**ADDENDUM to TECHNICAL DRAINAGE STUDY
FOR
824 South Decatur Blvd.
(Update for Goal Extended Stay)**

**JOB NO. 210261
September 2022**

3rd Submittal: Update #1

**Subject: Addendum to Technical Drainage Study for 824 South Decatur Boulevard (Update for
Goal Extended Stay)
CLV #DS4956C**

COMMENT #1

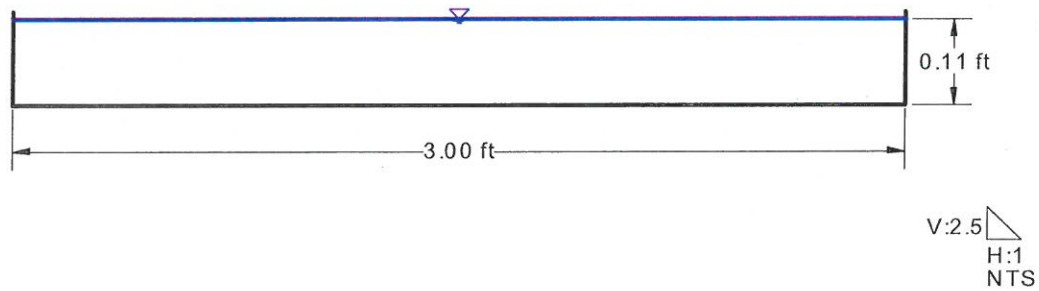
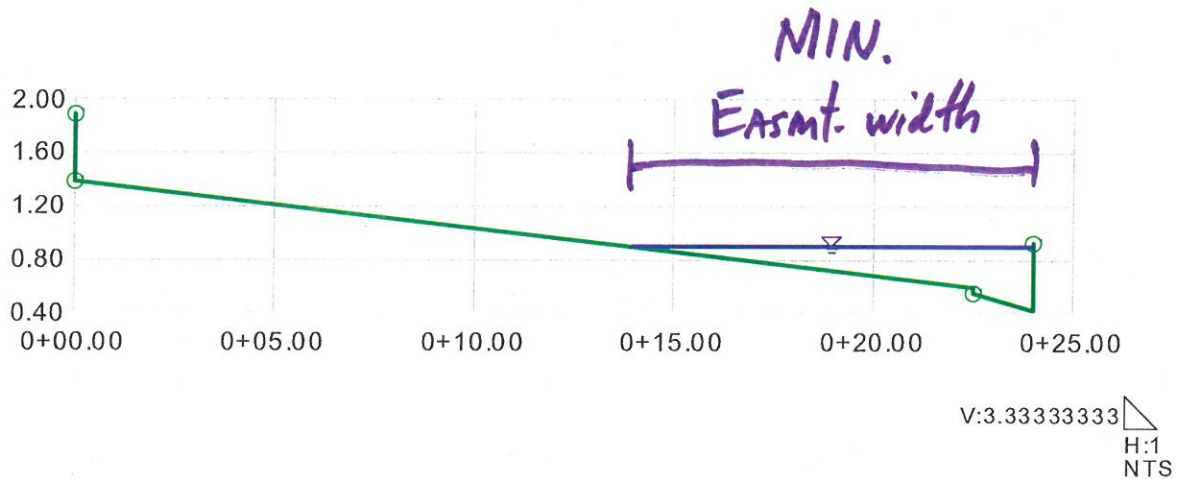
1. *FIG 5 (Developed Condition Basin Map): Hydraulic Section 1 is not found in any of the Summary Tables. Address and revise in the next submittal.*

Response: The Section 1 is in the Summary Table. It was just mislabeled as 1A and 1B. Also, please note that Section 2 was revised due to the design change for the easement flow to be in the drive aisle instead. A hydraulic section has been included at the upstream side of the building to show the FF is 18" above the 100yr flow depth suing the easement flow (4.20cfs). A section of the 3ft U channel has also been included for where the easement flow enters the site. A proposed drainage easement has been provided. See Plans and revised Figure DR5.

COMMENT #4

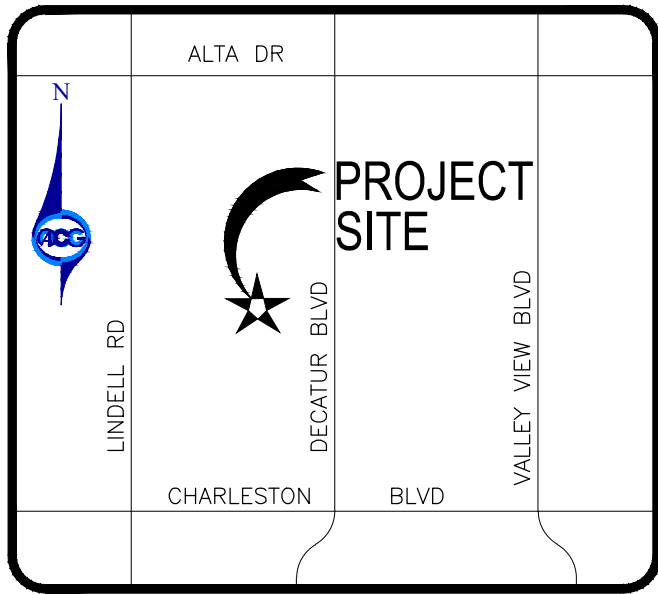
- For parking lot LID and storm water quality, the engineer must provide calculations (per *Section 1500 of the CCRFCD Hydrologic Criteria and Drainage Design Manual*) to justify that the length, width and depth of the landscape swales are meeting the design guidelines in an effective disconnected impervious areas layout.

4. For parking lot LID and storm water quality, the engineer must provide calculations (per Section 1500 of the CCRFCD Hydrologic Criteria and Drainage Design Manual) to justify that the length, width and depth of the landscape swales are meeting the design guidelines in an effective disconnected impervious areas layout.

Response: Noted. A BMP calculation spreadsheet has been provided. The BMP swales are treating 100% of the impervious site.

DRAWING NUMBER:
FIG 5

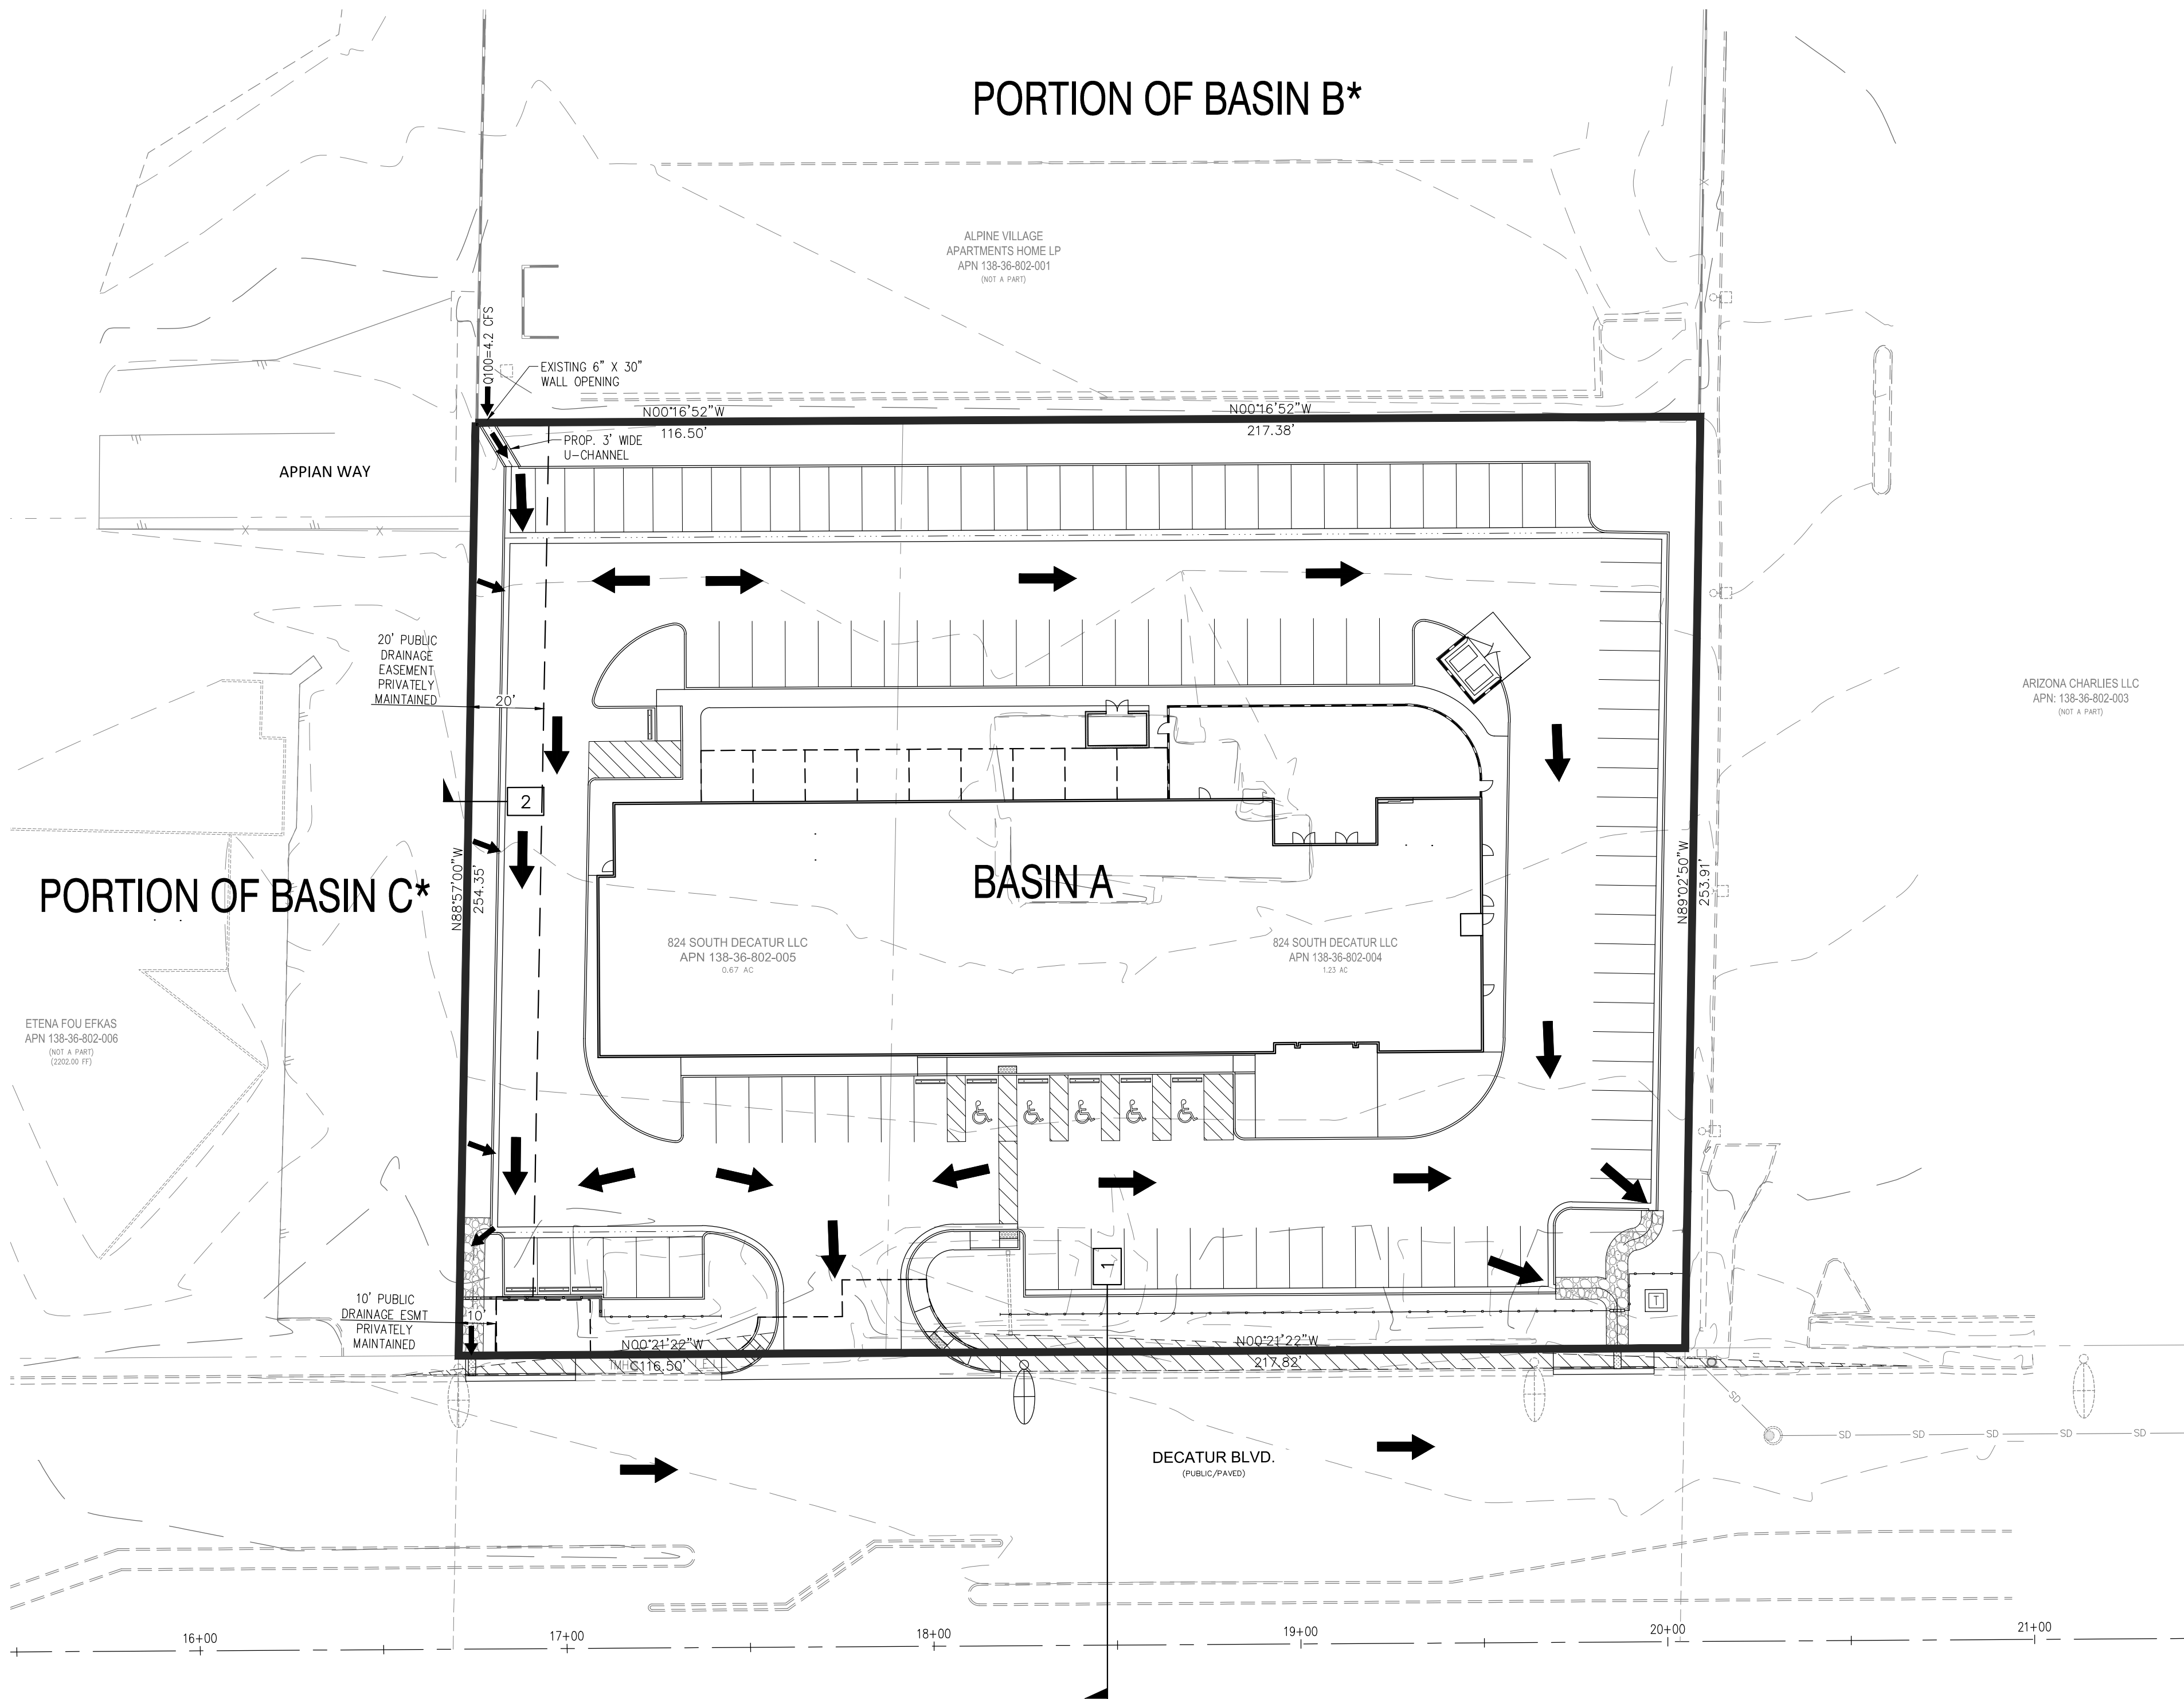
- FIG 5 (Developed Condition Basin Map):** *Hydraulic Section 1* is not found in any of the *Summary Tables*. Address and revise in the next submittal.

GRADING PLAN

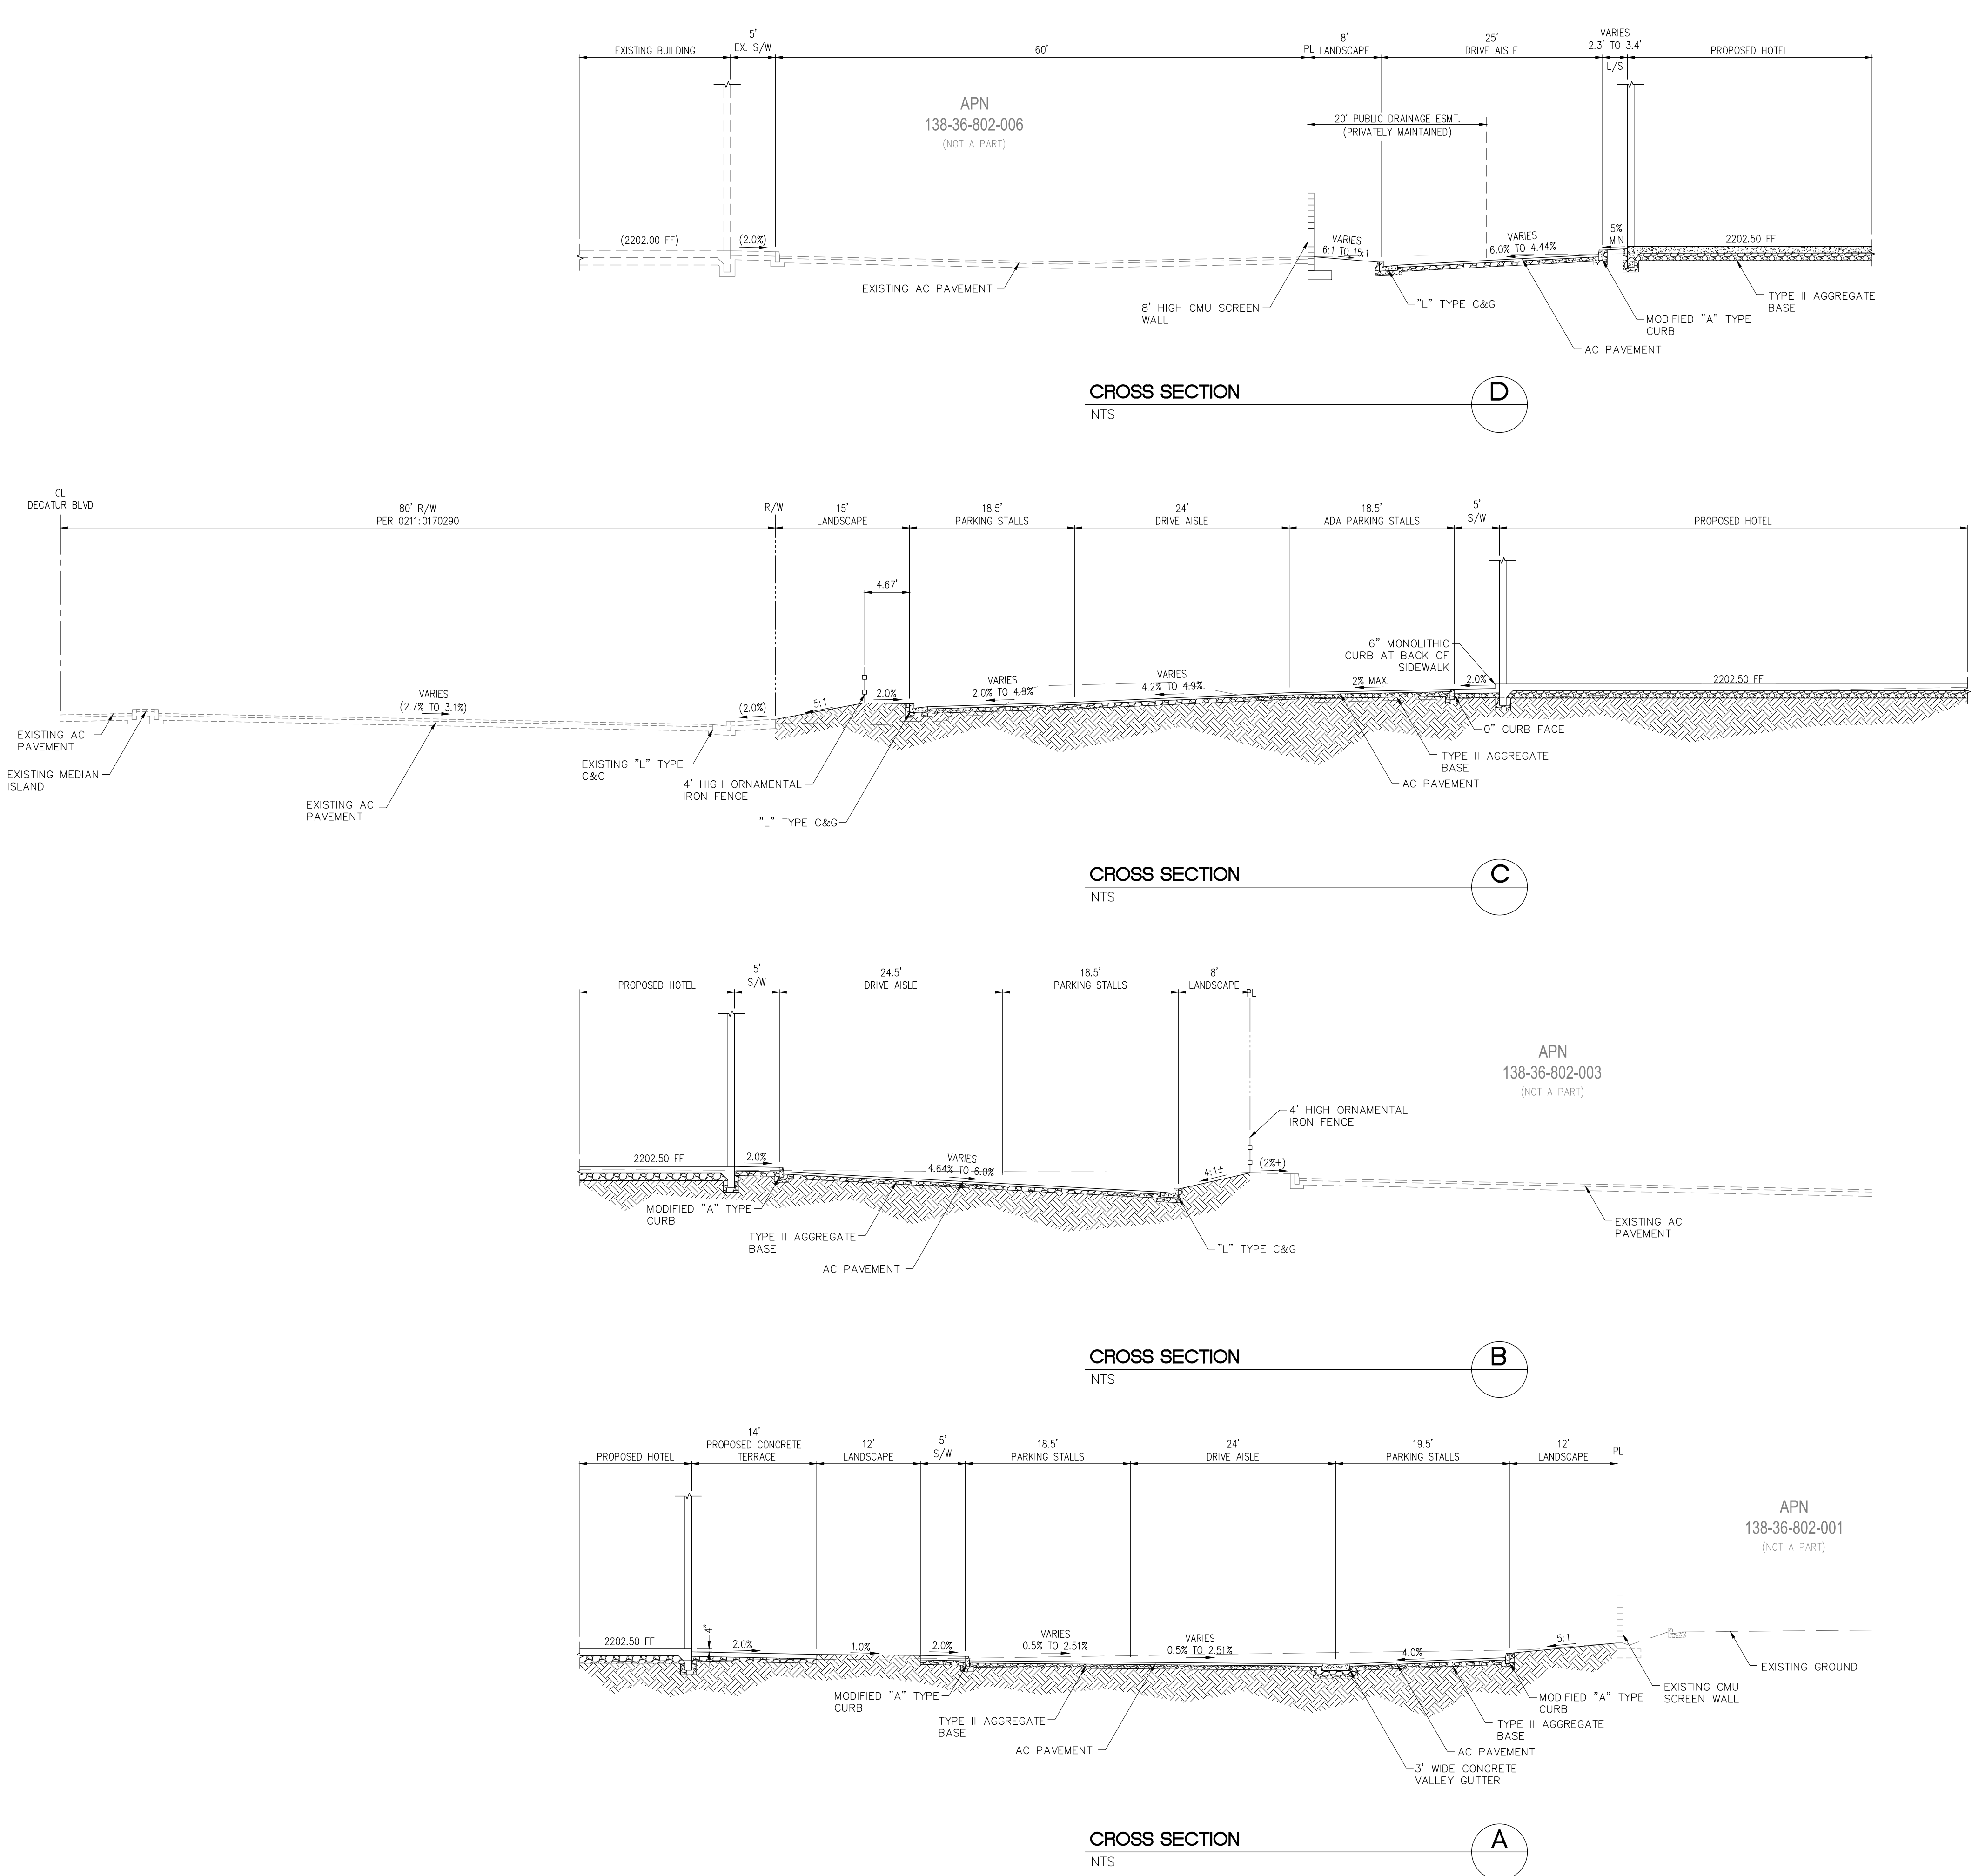
5. Label an existing storm drain in *Decatur Boulevard* with *City of Las Vegas* recorded drawing number on the grading plan. Identify all drop inlets and laterals with type and size information.
6. Provide current "Stormwater Management Notes" on the General Notes Plan.
7. Provide a note on all grading plans (Standard Note No. 6): Post-Construction BMPs (PCBMPs) / Control Measures noted on the Grading Plans are mandatory permanent regulatory stormwater pollution controls. These PCBMPs must be installed per the approved plans and must be permanently maintained.

5. Label an existing storm drain in Decatur Boulevard with City of Las Vegas recorded drawing number on the grading plan. Identify all drop inlets and laterals with type and size information.

7. Provide a note on all grading plans (Standard Note No. 6): Post-Construction BMPs (PCBMPs)/Control Measures noted on the Grading Plans are mandatory permanent regulatory storm water pollution controls. These PCBMPs must be installed per the approved plans and must be permanently maintained.

Response: Noted.

Response: Noted.
